MADRAS ELEMENTARY SCHOOL AND BUFF ELEMENTARY SCHOOL IMPROVEMENTS

PROJECT NO.: 22140B

ADDENDUM NO. 2

DATE: September 29, 2023

1 FLOOR PLAN-ELECTRICAL
1/16" = 1'-0"

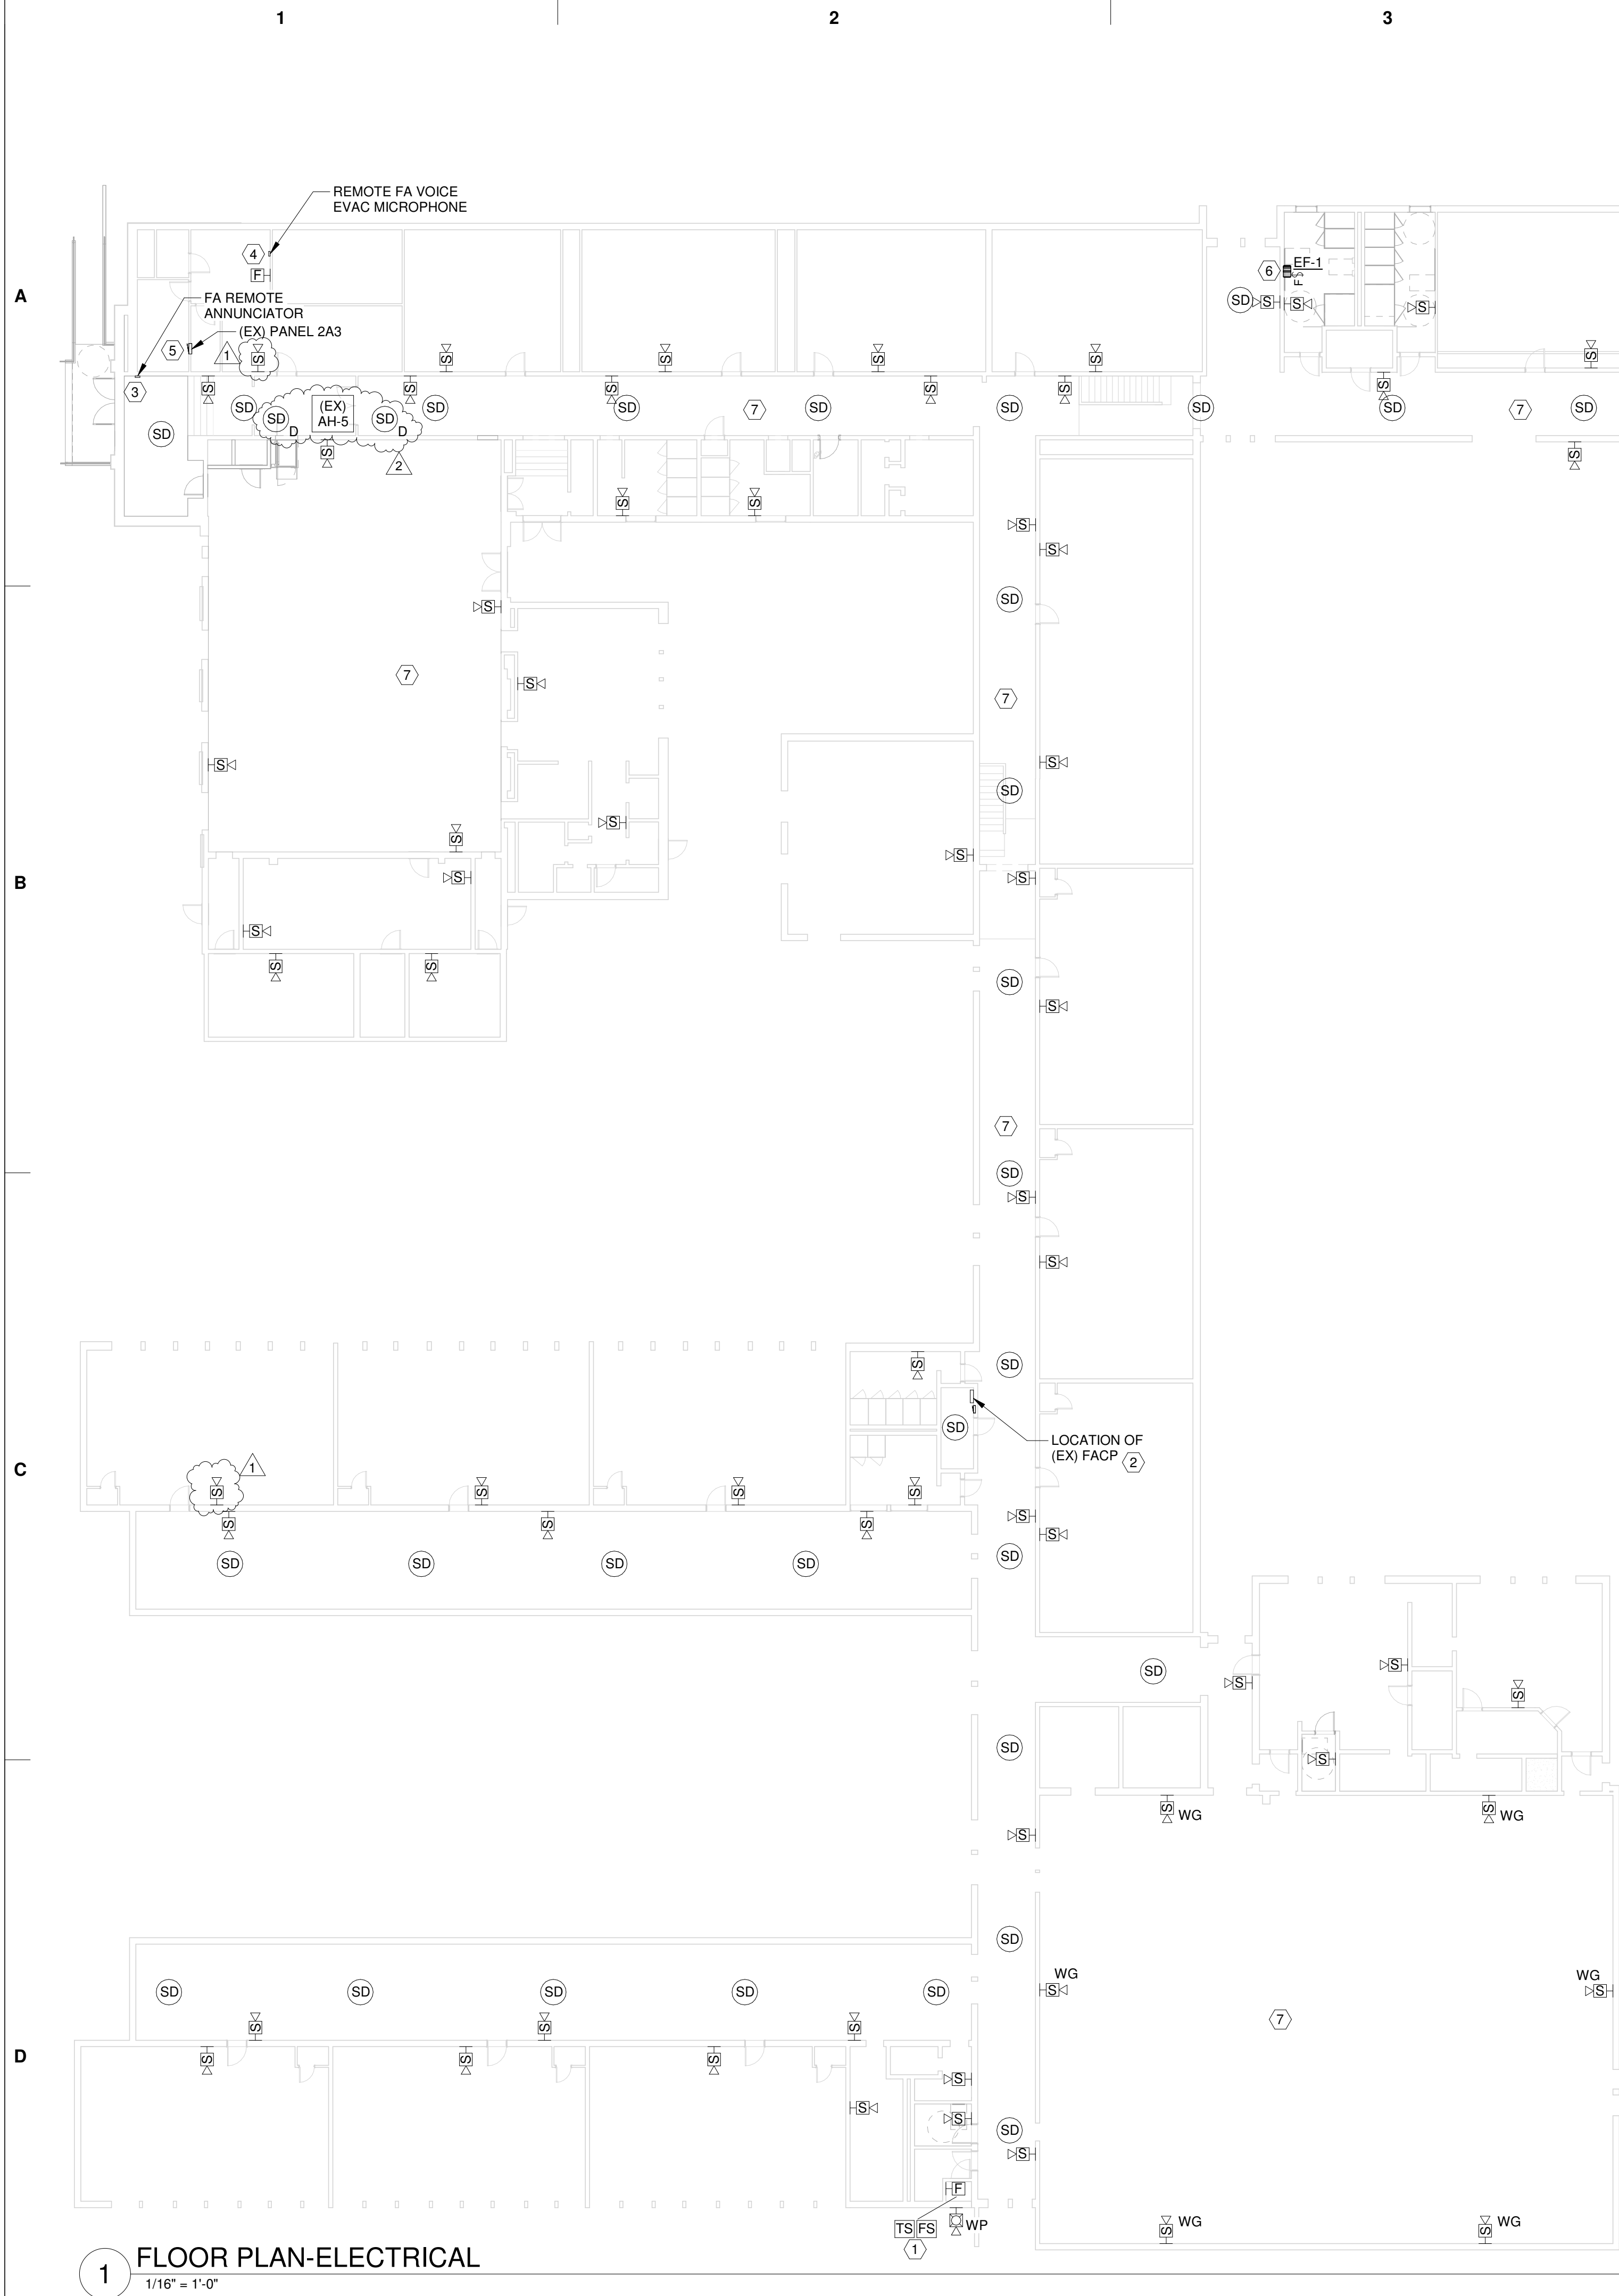
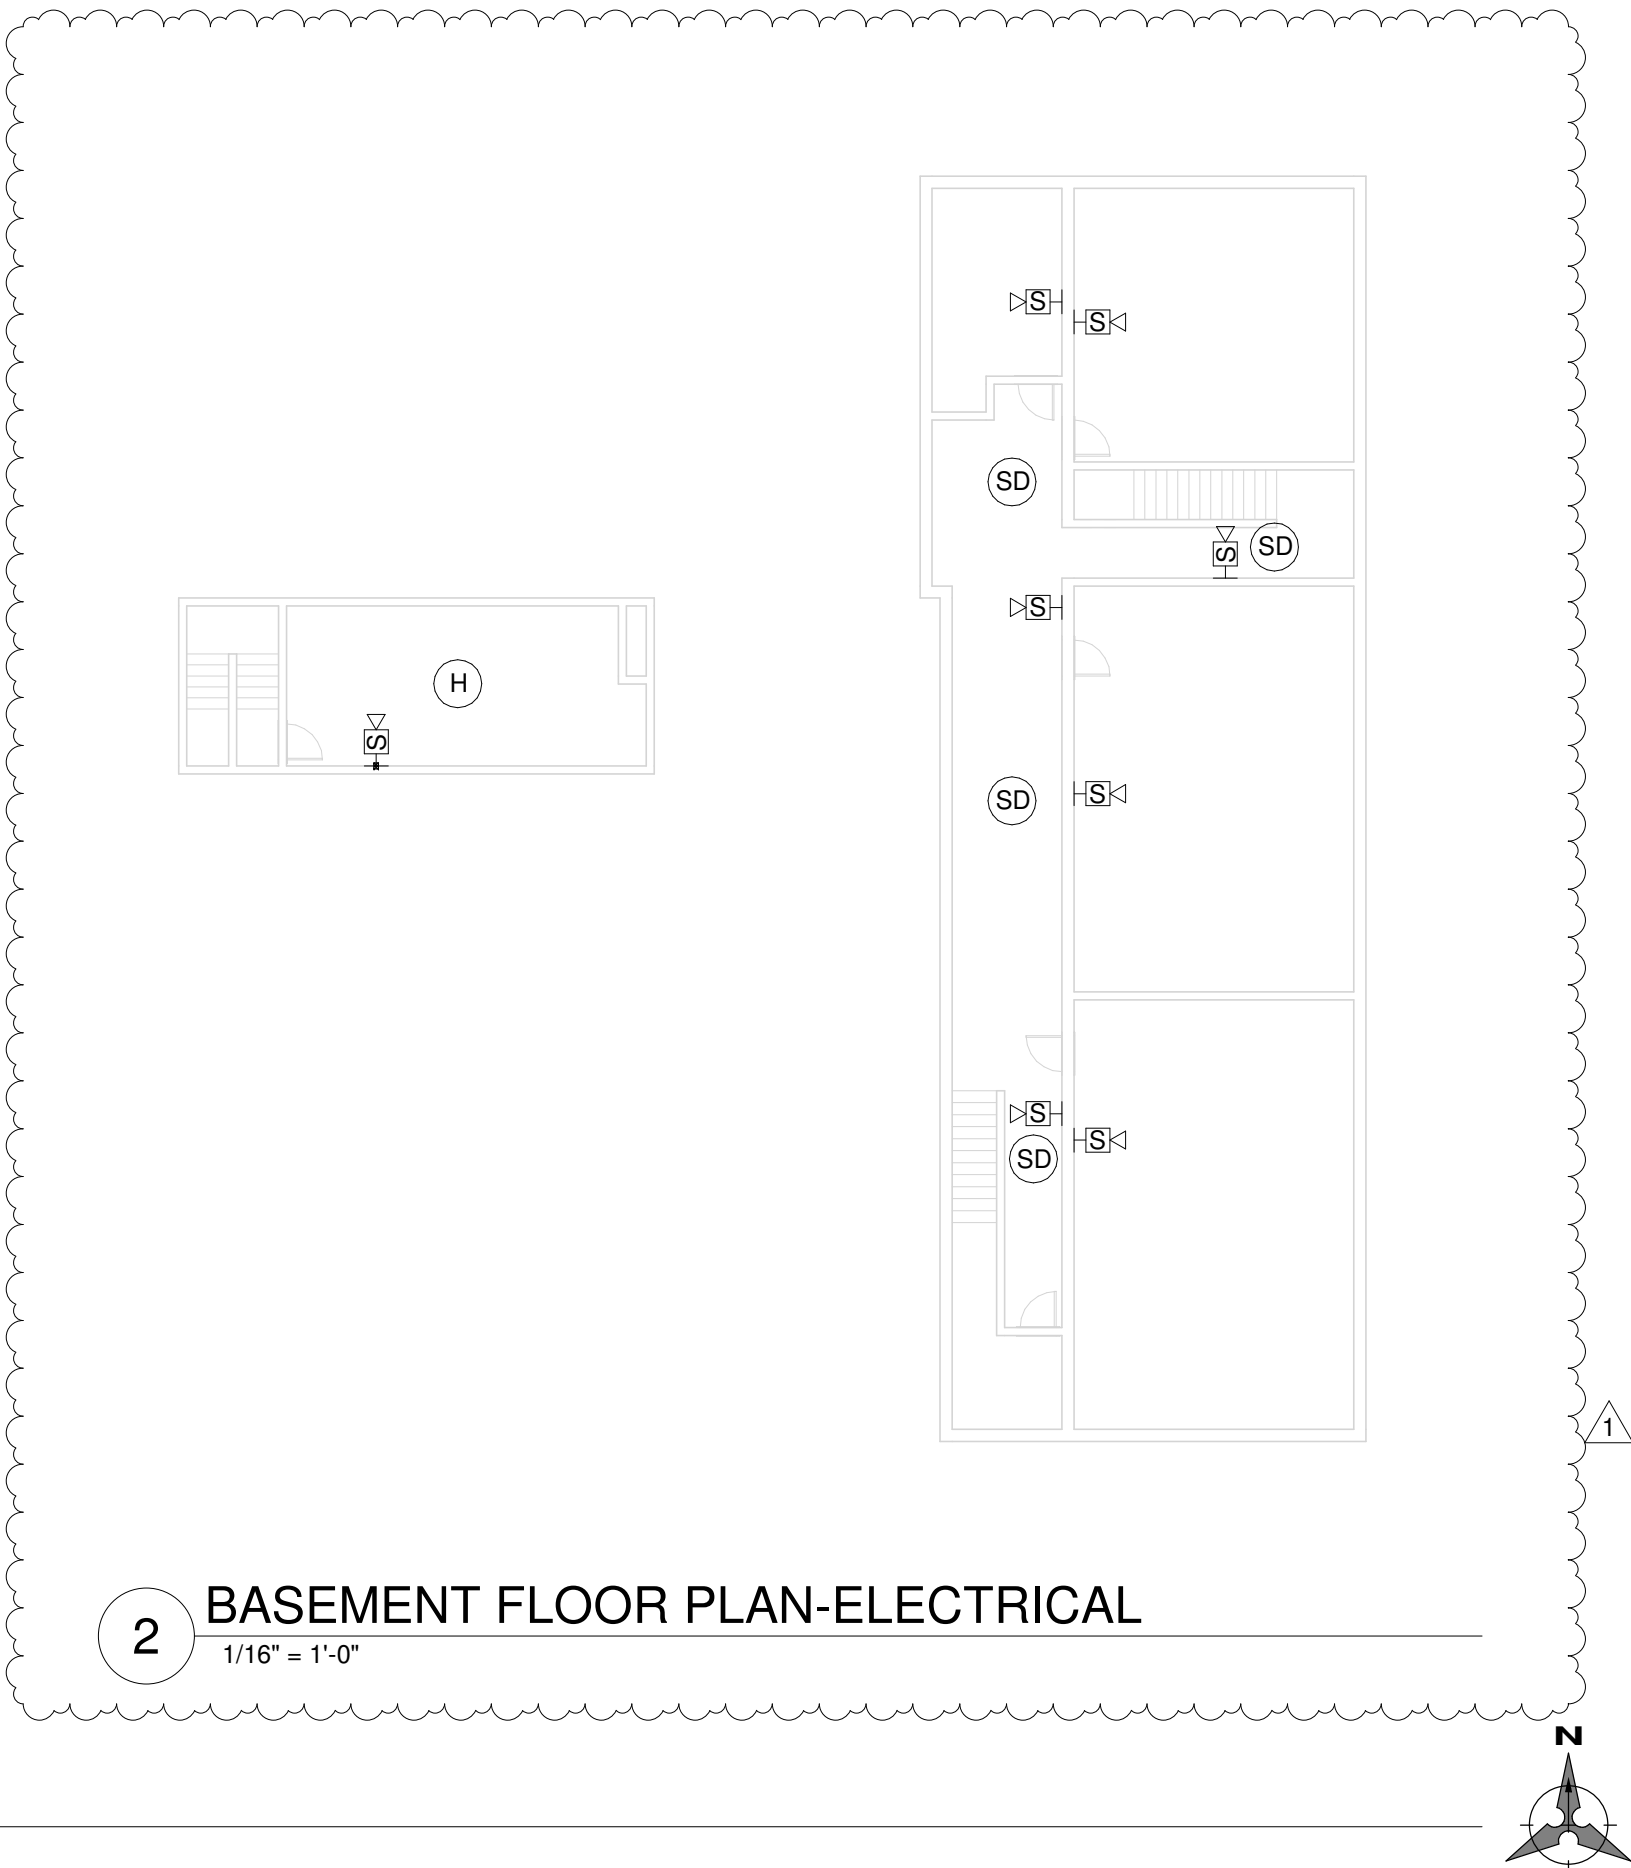
- Answer: There will not be any electrical work associated with this alternate.
3. Madras ES, Drawing E2.01 (Keynote #7): Says to provide duct detectors for existing equipment. There are no equipment schedules showing the existing mechanical equipment. Are there any equipment locations showing the locations? Will there be drawings provided so this scope can be included in the pricing, or should this be excluded.

10. E2.01 Electrical Floor Plan
 - a. Basement Plan is now shown.
 - b. Revised Keynote #7
 - c. Various revisions made to the main floor plan
11. ED2.01 Electrical Demolition Plan

- Answer: There are two existing units (RD-1 and AH-5) in the cafeteria area that move more than 2000 CFM air and will require duct-type smoke detectors. Presence of smoke at these detectors will shut down the respective unit, and these units will both shut down when the fire alarm system goes into general alarm.

7. PROVIDE DUCT-TYPE SMOKE DETECTORS IN (2) RETURN AIR DUCTS THAT SERVE EXISTING AIR HANDLING UNIT AH-5 IN ATTIC. ENSURE THAT DETECTION OF SMOKE WILL SHUT THE UNIT DOWN, AND TIE DETECTOR INTO THE NEW FACP.
